SUBJECT: Forwards responses to request for addl info re matrix power supply isolation device testing. Responses will be incorporated into FSAR in future amend.

Re: St. Lucie Unit 2
Docket No. 50-389
Final Safety Analysis Report
Requests for Additional Information

MATRIX POWER SUPPLY ISOLATION DEVICE TESTING

Figure - 1

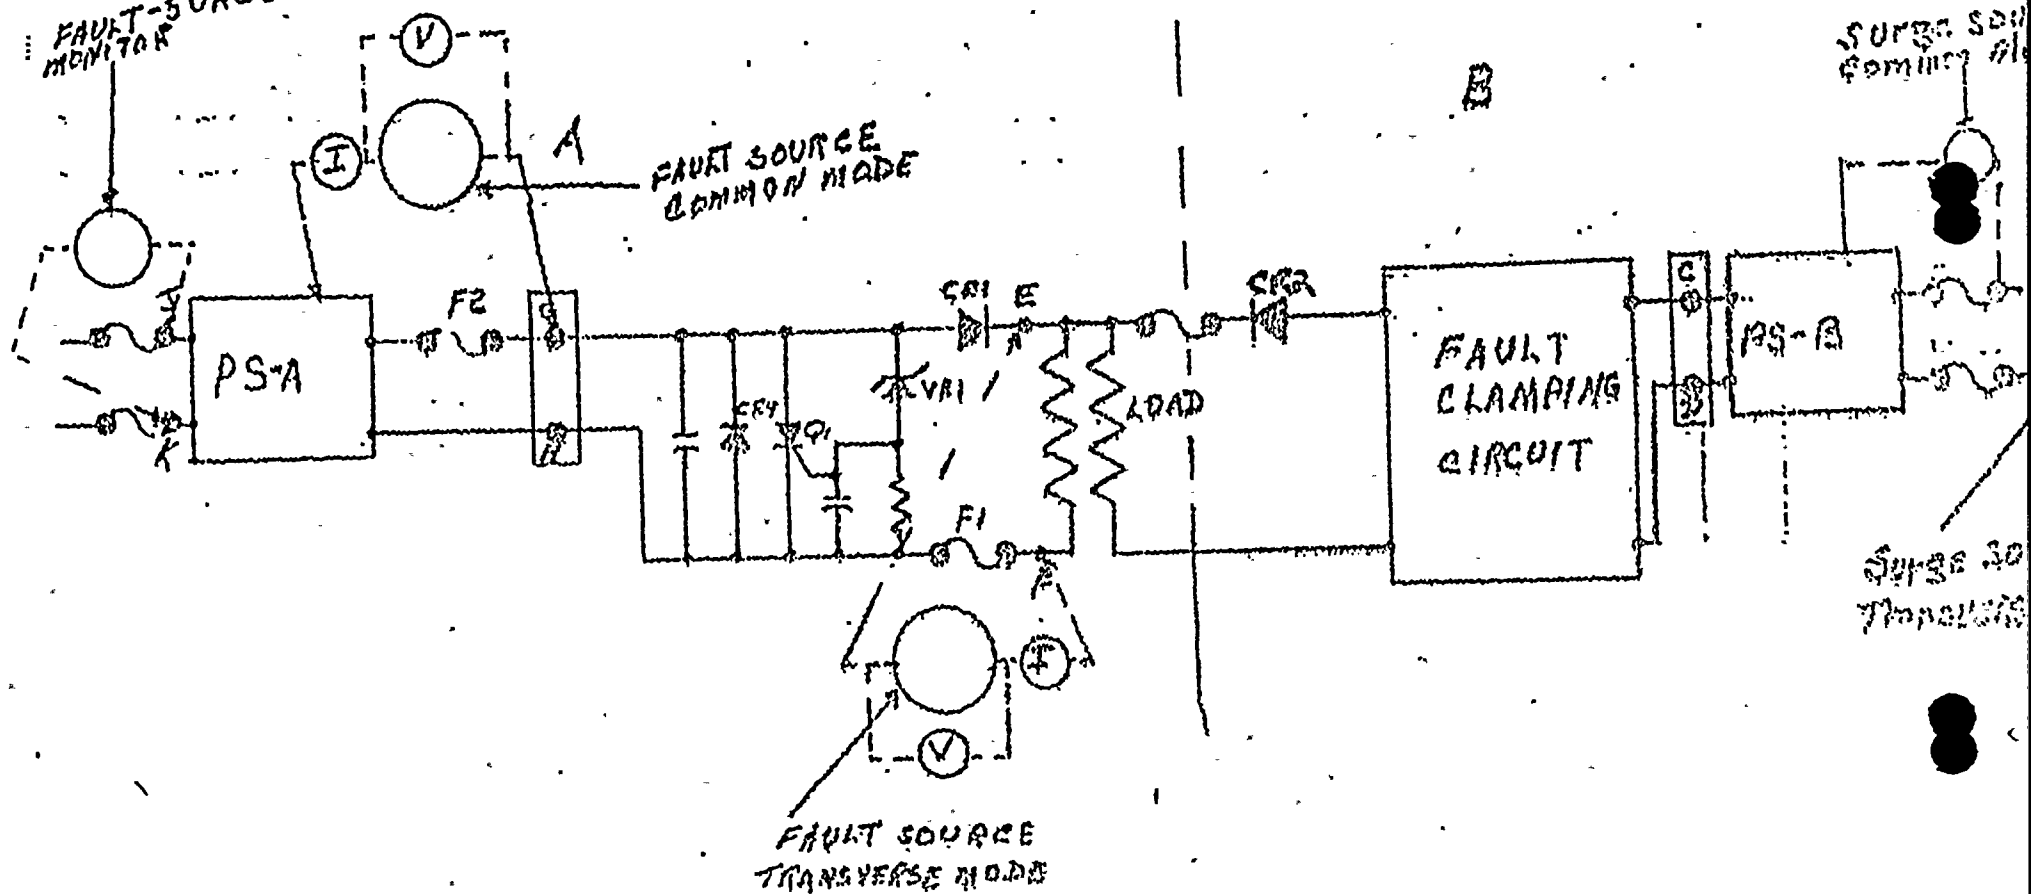
Matrix power supplies and isolation circuits are configured within the RPS as shown in Figure 1. The test involves simulating (with identical equipment) a typical RPS matrix (Figure 2) including bistable trip units, bistable power supplies, matrix power supplies, matrix relays, and isolation relays. Vital bus power (120 Vac) is simulated by using two power isolation transformers. The isolation test will consist of the application of a 600 Vac and 400 vdc fault in the circuit in the common and transverse modes. The basis for the 600 vac and the 400 Vdc test voltage is as follows:

The common mode test is accomplished by applying a fault to the DC side of a matrix power supply between point (G) and the power supply chassis. The fault voltage and current are monitored to define the fault characteristics. Also, the 120 Vac line side of the power supply is monitored to document any effect as a result of application of the fault. All monitoring is by means of a light beam recorder. This same process is repeated for point (H) to the power supply chassis.

For the purpose of this test, it has been conservatively assumed that if a fault appeared on vital bus B (points A or B to chassis ground in Figure 1) it

would propagate through the DC power supply (PS-B) and appear at points C or D. Since PS-B is directly connected to PS-A (through CR-1 and CR-2) the fault is assumed to appear at points G or H to ground. Therefore, it is required to show that when a fault is present on the DC side of a matrix power supply it does not propagate to the 120 Vac side of the power supply, thereby affecting more than one vital bus. It should be noted that complete propagation of a fault from power supply primary to secondary is a conservative fault circuit evaluation which would most likely not occur.

The transverse mode test is accomplished by applying the fault directly to the output terminals (E and F) of the isolation circuit. This fault voltage and current are monitored to define the fault characteristics. Also, the input side (G and H) of the isolation circuit and the 120 Vac line side (J and K) of the power supply is monitored to document any effects as a result of application of the faults. All monitoring is by means of a light beam recorder.

Similar to the common mode test, a fault appearing on vital bus B (Figure 1 points A and B) is assumed to propagate completely to points E and F. Therefore, it must be shown that application of a fault to the output of the isolation circuit (points E and F) does not propagate in the 120 Vac side of power supply A thereby affecting more than one vital bus. It should be noted that the isolation circuit clamps the fault voltage such that power supply damage does not occur, as discussed below:

Clamp Circuit - The power supply fault clamp circuit is designed to limit or shortout a positive or negative fault. Figure 1 is a schematic of the fault clamp circuit which is connected to each matrix power supply. During normal operation VRI is in the open circuit condition, SCR-Q1 is deenergized and CR4 is reverse biased. The normal 28 Vdc output of the power supply will be seen between points E and F.

The clamp circuit operates in the following manner. On the negative cycle, the fault is clamped or shorted out by CR4, causing F1 to open. On a positive cycle, the fault would cause VRI to conduct upon reaching an amplitude to 47V (combined 28V PS volts and 19V fault).

With VRI conducting, SCR-Q1 will energize, shorting out or clamping the fault and the power supply output, causing F1 and F2 to open.

The common mode test is accomplished by applying a surge to the AC side of the matrix power supply between point (A) and the power supply chassis. During surge application the simulated RPS circuit is operated to show proper function and accuracy. Also, the 120 Vac line of the associated power supply is monitored across points (J) and (K). The same process is repeated for point (B) and the power supply chassis.

The transverse mode test is accomplished by applying a surge to the AC side of the matrix power supply between points (A) and (B). During application of the surge the simulated RPS circuit is operated to show proper function and accuracy. Also the 120 Vac line of the associated power supply is monitored across points (J) and (K).

Figure - 2.

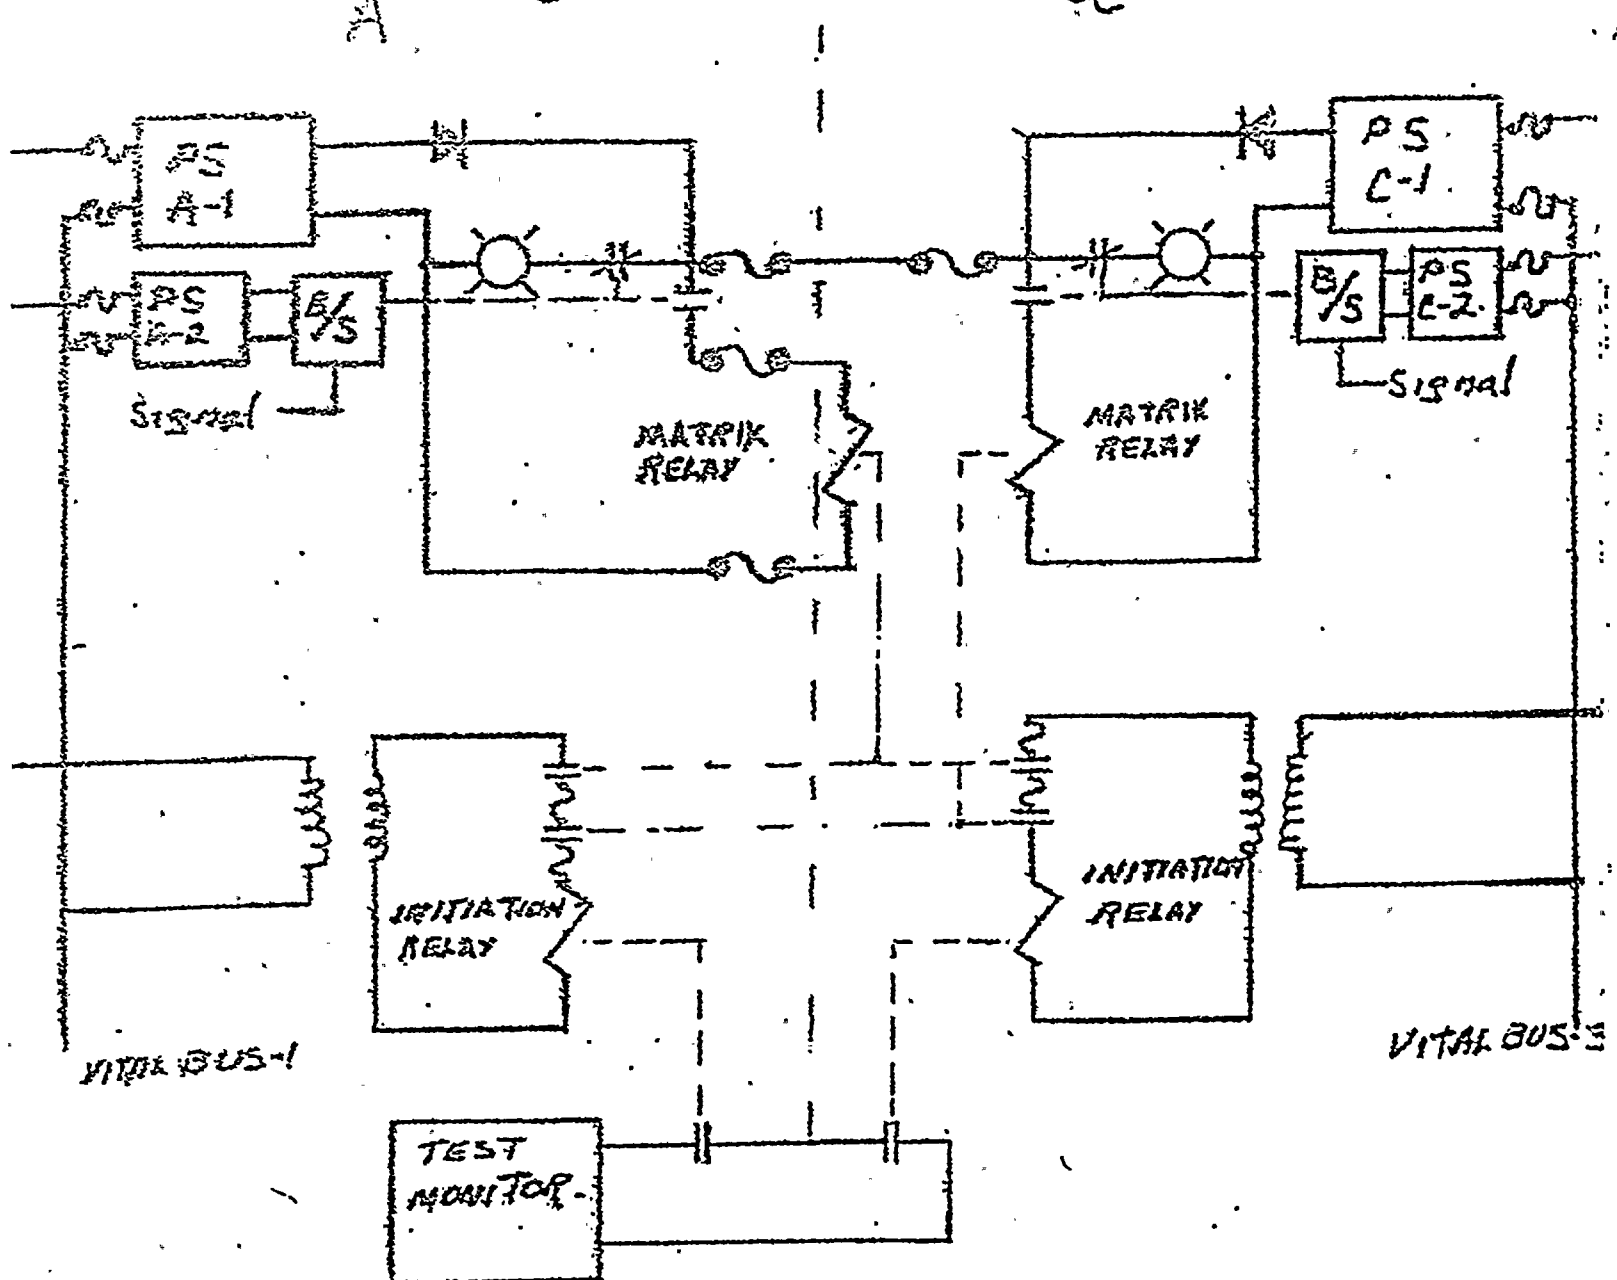
The test involves simulating (with identical equipment) a typical RPS matrix (Figure 2) including bistable trip units, bistable power supplies, matrix power supplies, matrix relays, and isolation relays. Vital bus power (120 Vac) is simulated by using two power isolation transformers. A 300 Vac surge (negative peak to positive peak) will then be superimposed on one vital bus. Thus, the test voltage from neutral to peak will be 337 volts (120 Vac + 10%) x 1.414 plus the neutral to peak surge 300V/2. The surge voltage is based on a calculation performed for the ANO-2 PPS which concluded that circuit damage or false operation would not occur provided the peak AC voltage is maintained below 400 Vac. The calculation is based on dielectric strength of materials within the ANO-2 PPS. Since the equipment within the St. Lucie Unit 2 PPS is similar (but not identical) to the ANO-2 PPS it is assumed that calculation conclusions are applicable to the RPS.
